Steven Velardo
164 East Middle Patent Road
Bedford, NY 10506

RE: 164 East Middle Patent Road
Bedford, NY 10506
Section 95.02 Block 2 Lot 22

Thank you for the opportunity to present my revised submission based on the comments from the previous Planning Board meeting of November 9, 2020.

Staff Comments Planning department memo dated 11/3/2020

Drawn By: JA
 Project #: 01-20
 Sheet Number:
LW-1
 Scale: 1" = 20'-0" Issue Date: February 22, 2021

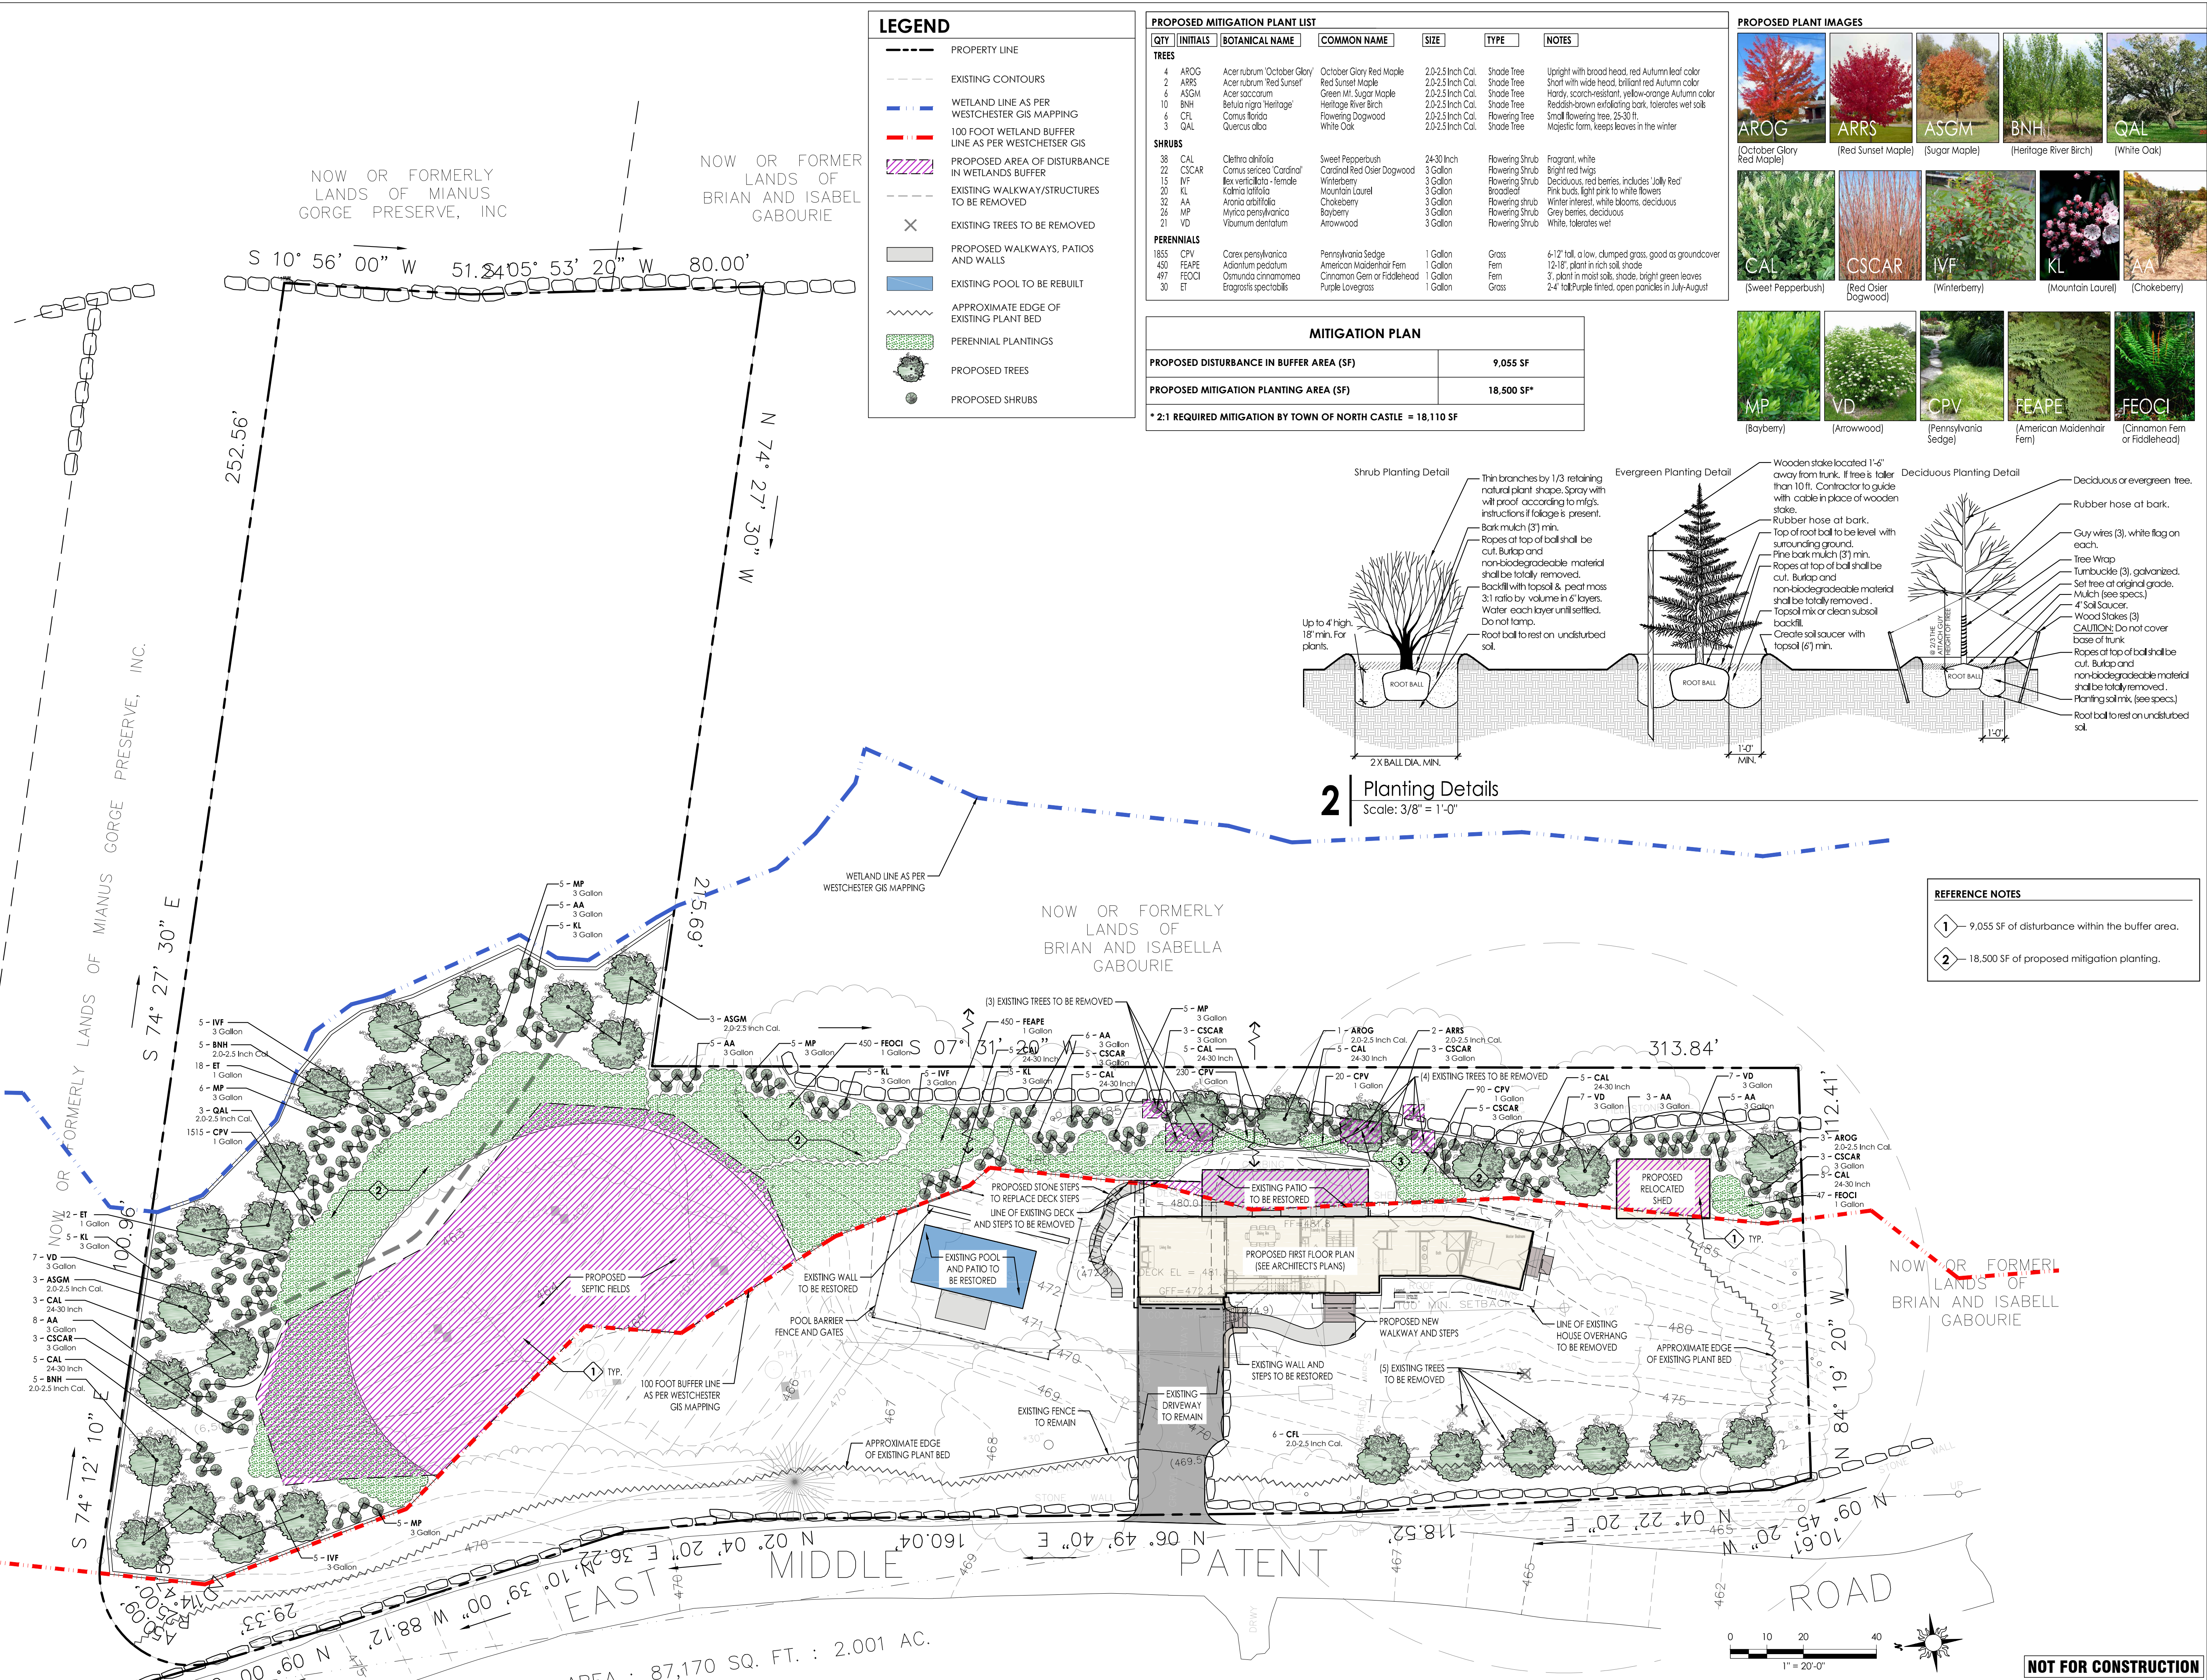
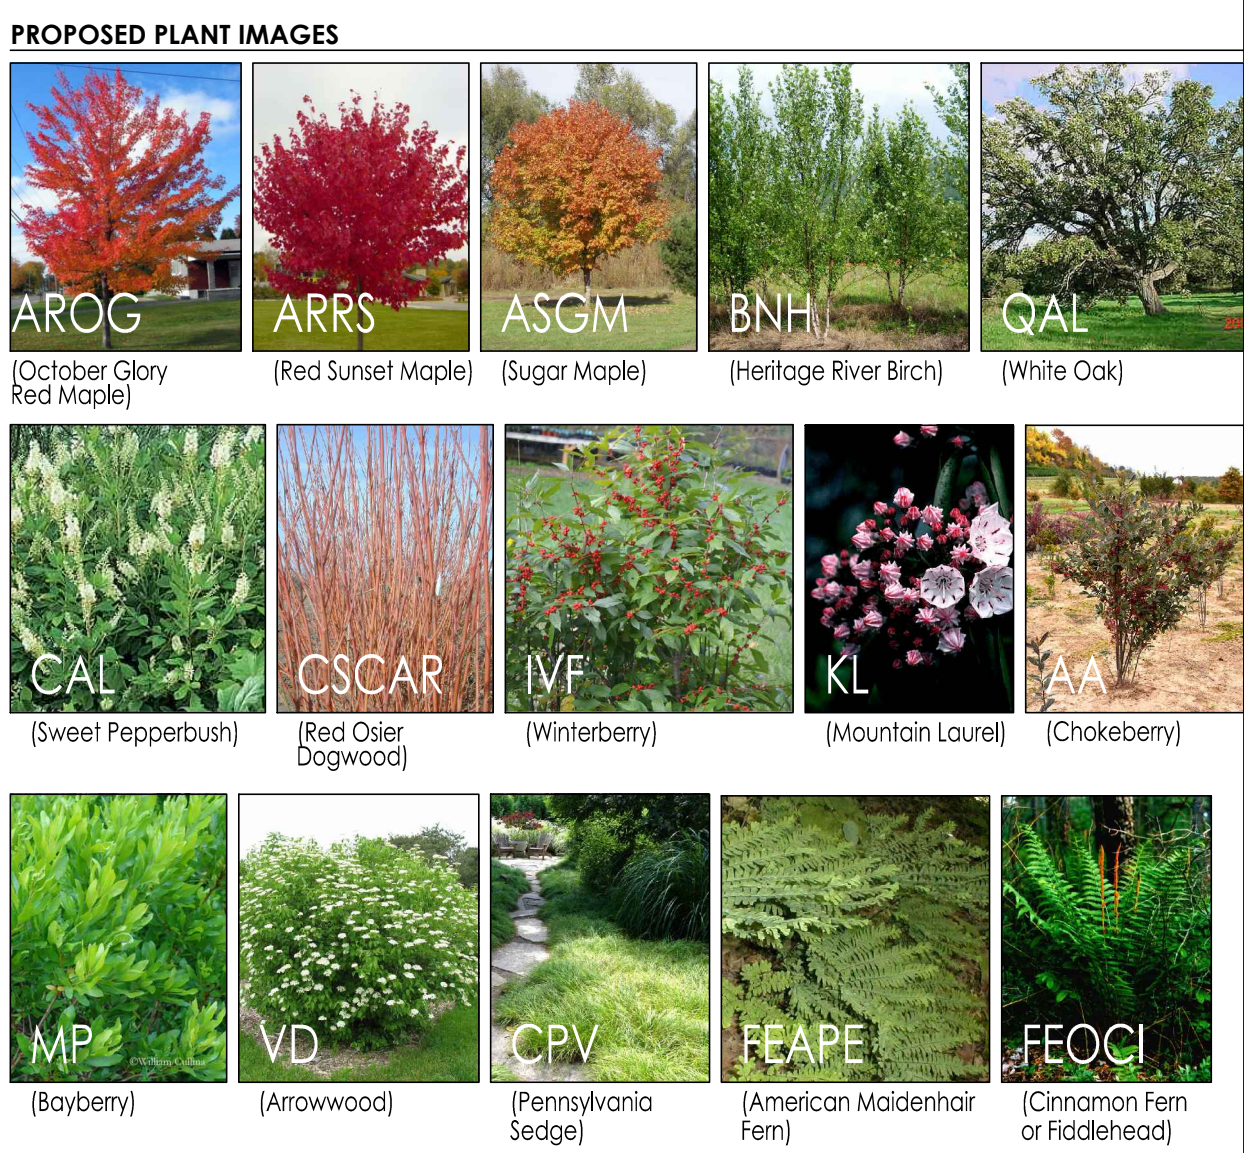
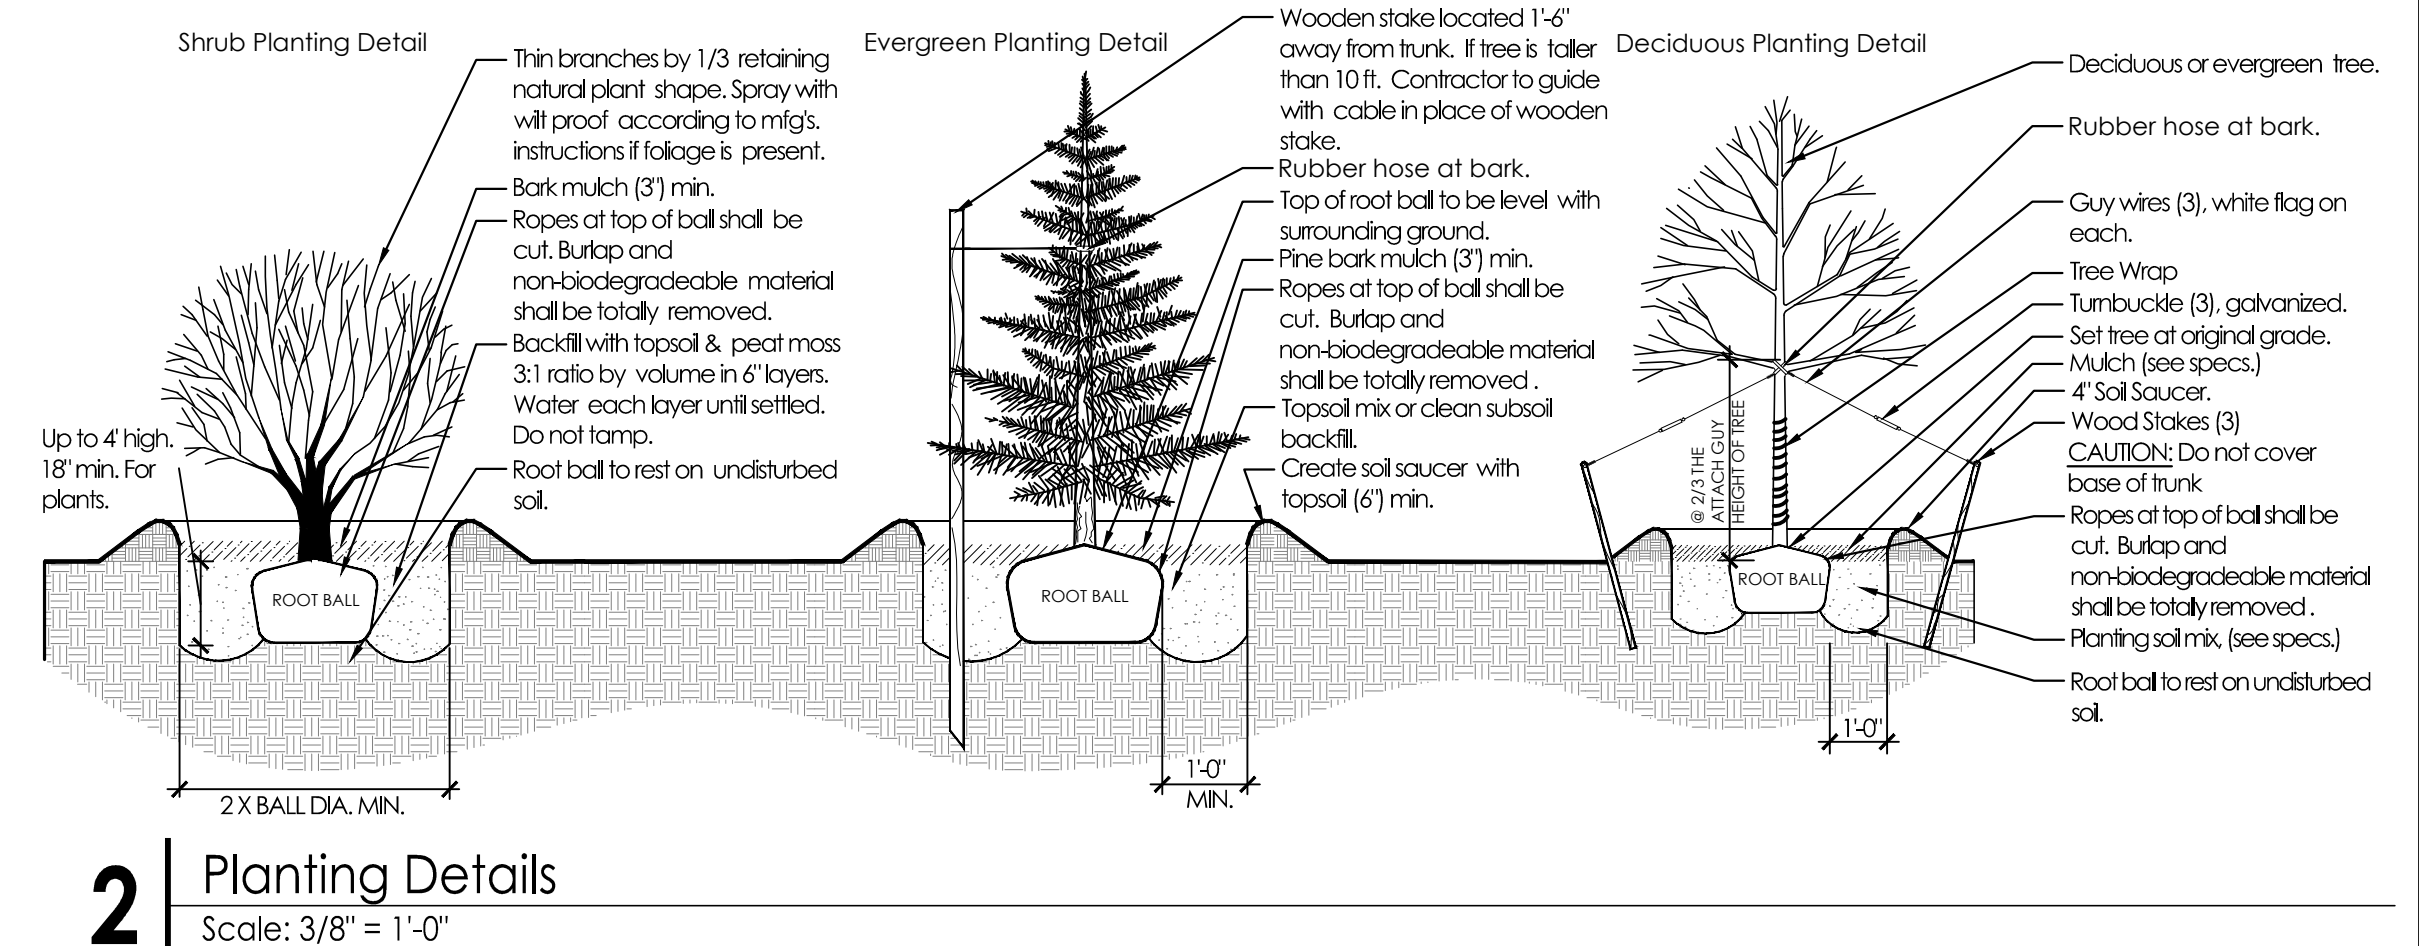
4. The applicant shall prepare a Mitigation Plan, in accordance with Chapter 340-9,

As proposed on Revised Wetlands Mitigation Plan LW-1 Dated 1/25/2021

As proposed on Revised Wetlands Mitigation Plan LW-1 Dated 1/25/2021

As proposed on Revised Wetlands Mitigation Plan LW-1 Dated 1/25/2021

As proposed on Mitigation Plan LW-1 Dated 1/25/2021

As proposed on Mitigation Plan LW-1 Dated 1/25/2021

As proposed on Revised Mitigation Plan LW-1 Dated 2/22/2021 with revisions based on resolution for approval by the Conservation Board.
